Reference: Beaver Valley Power Station, Unit No. 1
Docket No. 50-334, License No. DPR-66
Bypass Breaker Status Indication,
Generic Letter 83-28, Item 4.3

Beaver Valley 1 Response to
NRC Safety Evaluation Report on
Generic Letter 83-28, Item 4.3,
Automatic Shunt Trip Modification

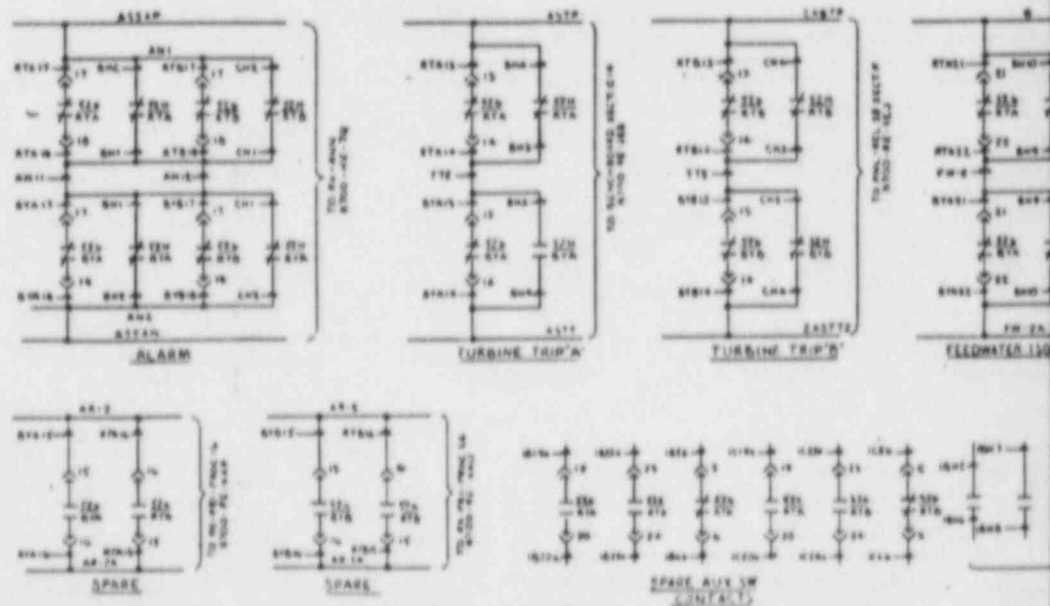
- (a) Submission of revised information including revised electrical schematics showing provisions of bypass breaker position status lights on the main control board as noted in Item 1.

Attached is a preliminary electrical elementary diagram for the proposed automatic shunt trip modification. This diagram identifies the bypass breaker UVTA circuit, STA circuit, breaker controls and breaker status/alarms.

As part of the modification, breaker position indicating lights are to be added for the bypass breakers. The lights are to be powered from the same 125VDC supply as the shunt trip and closing circuit. The green light is to be in series with a "b" auxiliary contact, which will indicate breaker open and power available for closing. The red light is to be in series with the shunt trip coil and an "a" auxiliary contact, which will indicate breaker closed, power available for tripping and shunt trip coil continuity.

Tentatively, the status lights are proposed to be installed on Section B of the Main Control Board near the reactor trip breaker control switch, 1-RTC. However, with the limited open area around the switch, the exact location cannot be determined until the detailed design is complete.
